DEPARTMENT OF ENVIRONMENTAL PROTECTION
BUREAU OF REMEDIATION AND WASTE MANAGEMENT

M E M O R A N D U M

DATE: January 15, 2016

RE: Juniper Ridge Landfill Expansion Application
Volume II, Site Assessment Report and
Volume III, Design Report
Volume IV, Operations Manual, July 2015

JUNIPER RIDGE PROPOSED LANDFILL EXPANSION DEP - FIGURE 1

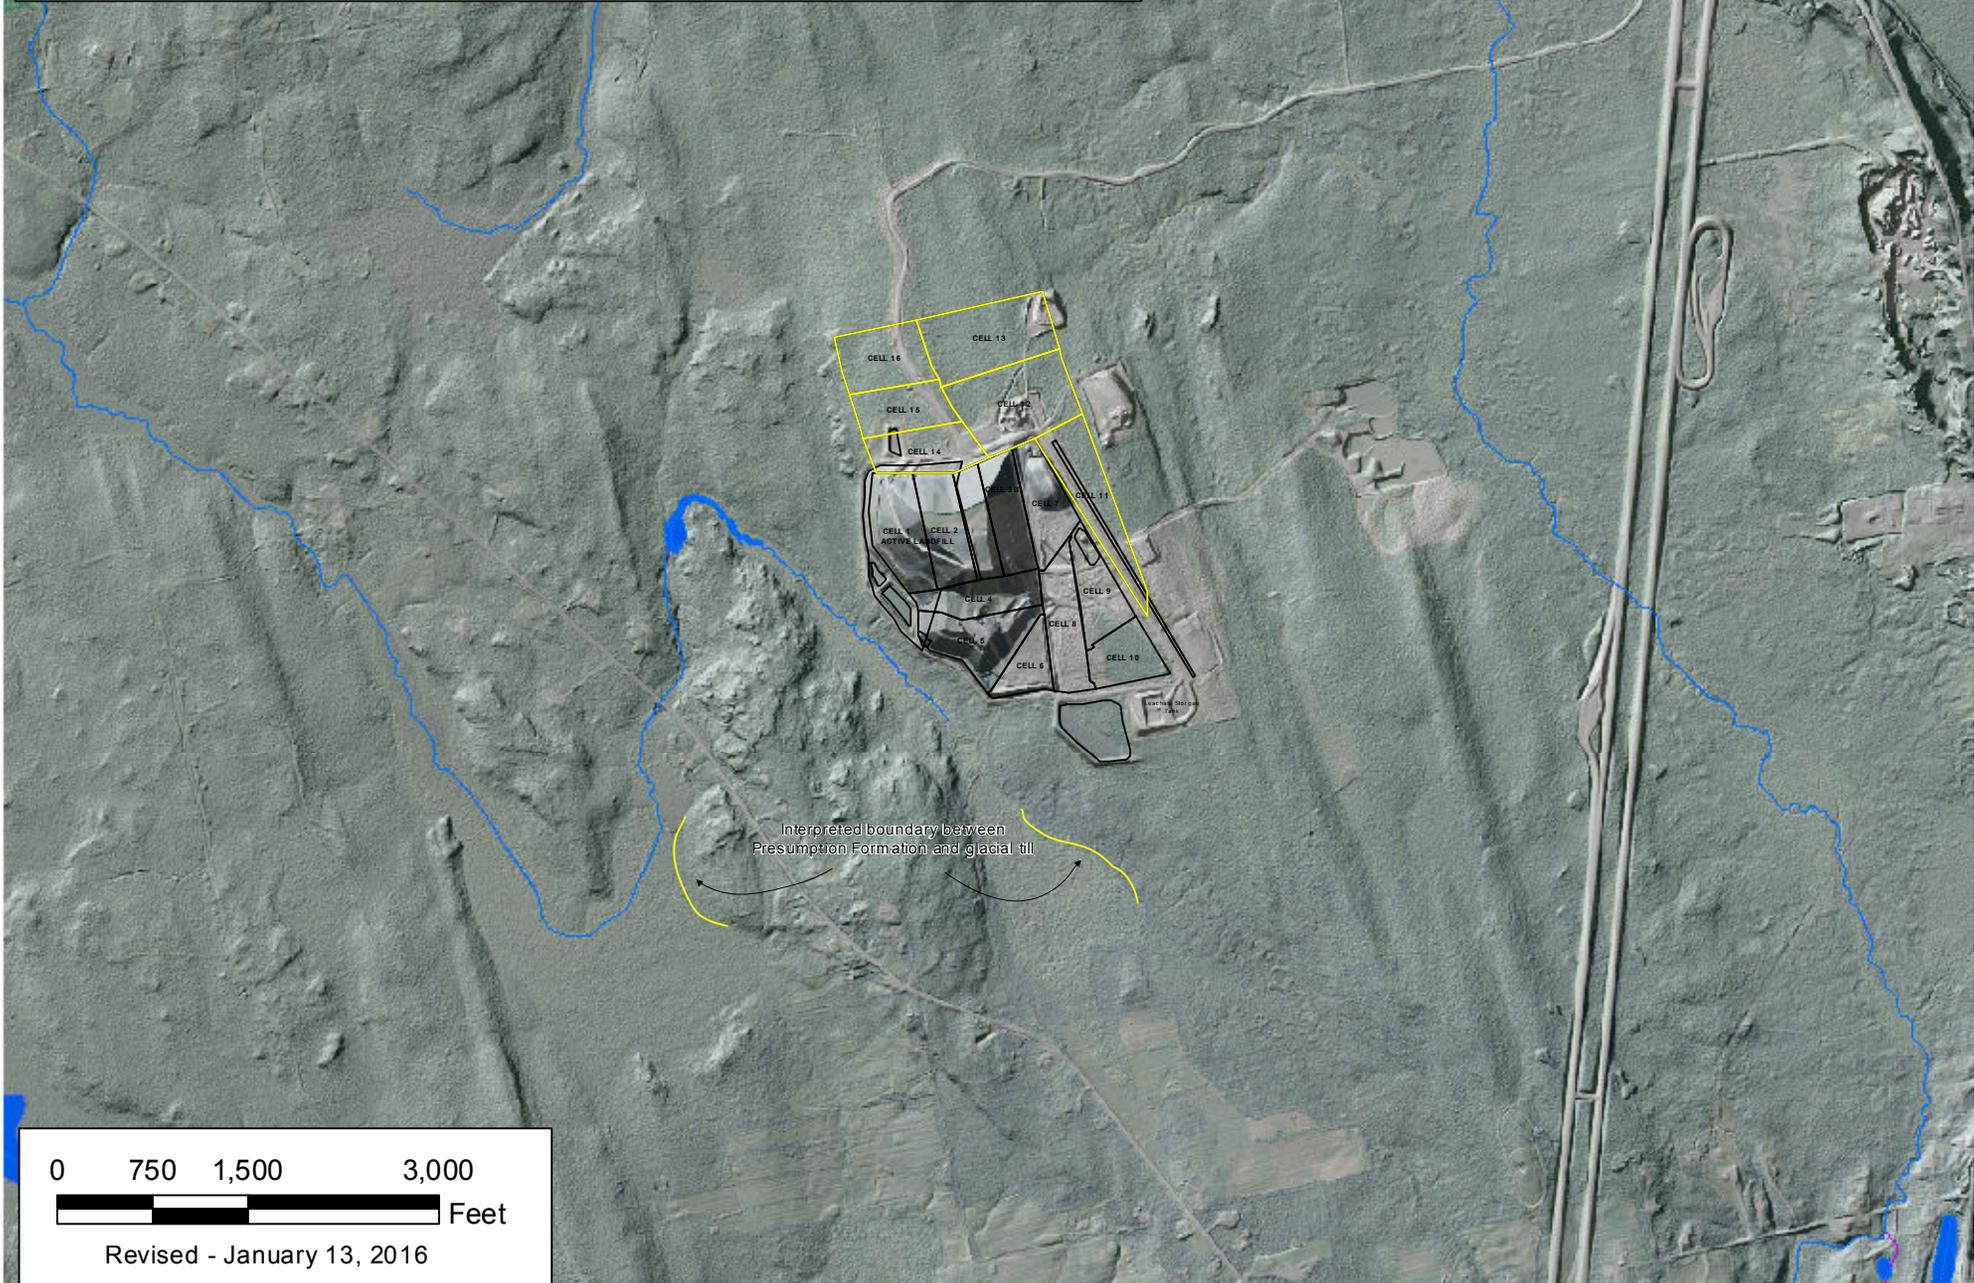
NEWSME Landfill Operations, LLC has prepared and submitted an application in support of its proposal to construct a 54 acre expansion of the existing 68 acre secure Juniper Ridge Landfill facility (JRL) located in Old Town, Maine. The proposed expansion, as designed, consists of six secure landfill cells (Cell 11 through 16). Cell 11 is positioned due east of the existing Cells 7 and 9 while the remaining proposed cells are located due north of the existing permitted facility (**DEP - Figure 1**).

DEP -Figure 3

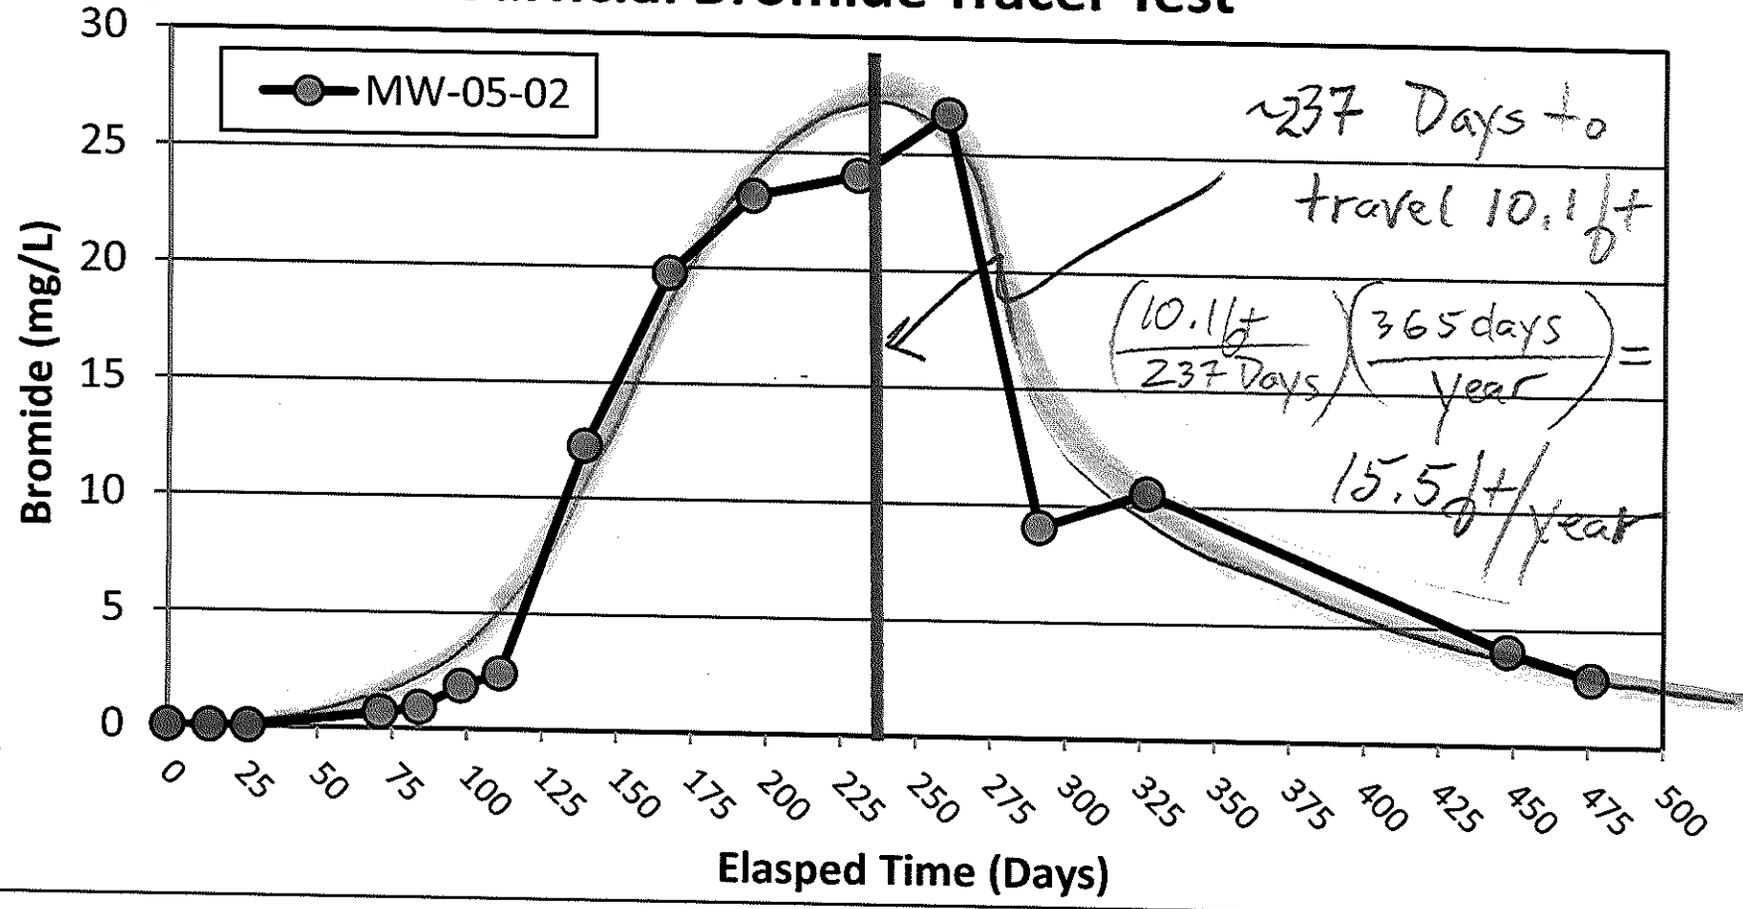
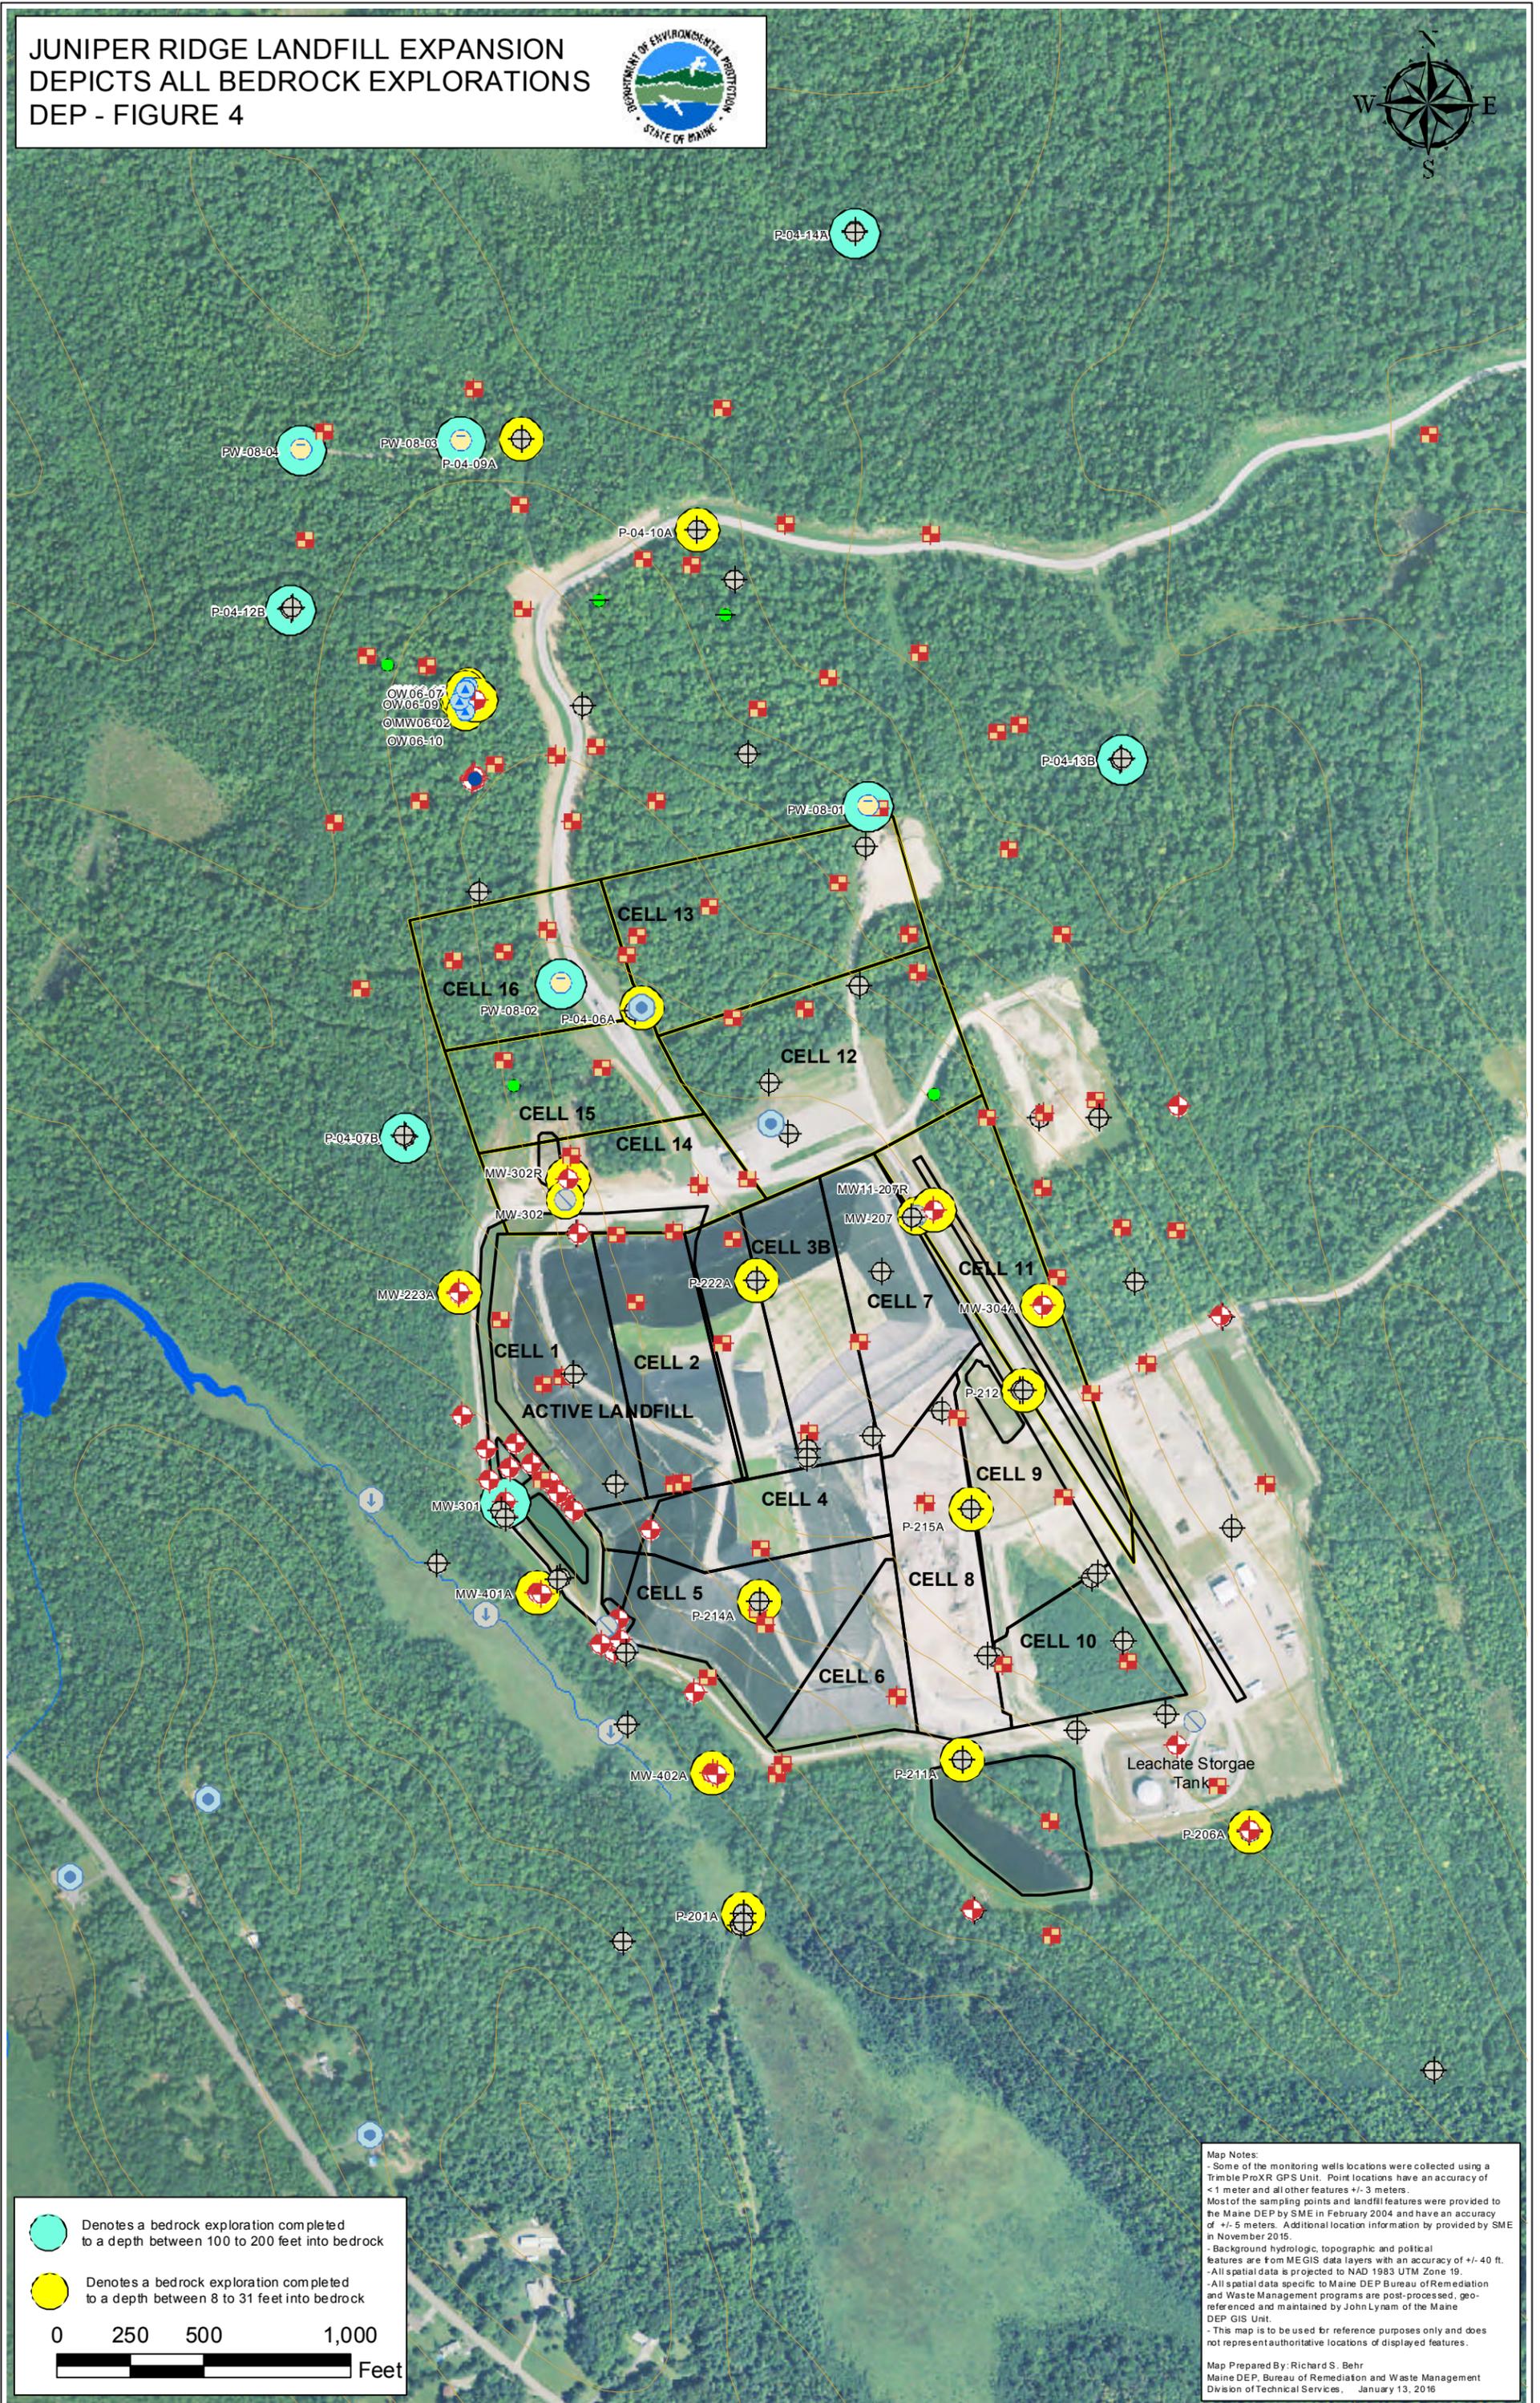
To provide additional data about groundwater velocities in the till, JRL conducted a tracer test using sodium bromide. I have reviewed the details of the test contained in Appendix G. The analytical solutions produced an estimated velocity of 11 ft/year. Interestingly, the estimated velocity based on the arrival of the peak bromide concentration (i.e., graphic solution) yields a slightly higher velocity of 17 ft/year. I too analyzed the data graphically (**DEP - Figure 3**) and calculated a velocity of 15.5 ft/year.

It seems to me the graphically derived solution may be more representative of the in-situ velocity. Particularly since the well containing the highest bromide concentrations is likely not directly downgradient of the injection well. Perhaps more importantly, this test was not conducted within the proposed expansion area. I recognize the till in and around the proposed expansion may be relatively uniform, but ideally I would expect tests like this would be performed within the foot print or directly downgradient. JRL should, to the extent possible, explain why the results of a tracer test conducted several hundred feet from the expansion are representative of site conditions beneath the proposed expansion.
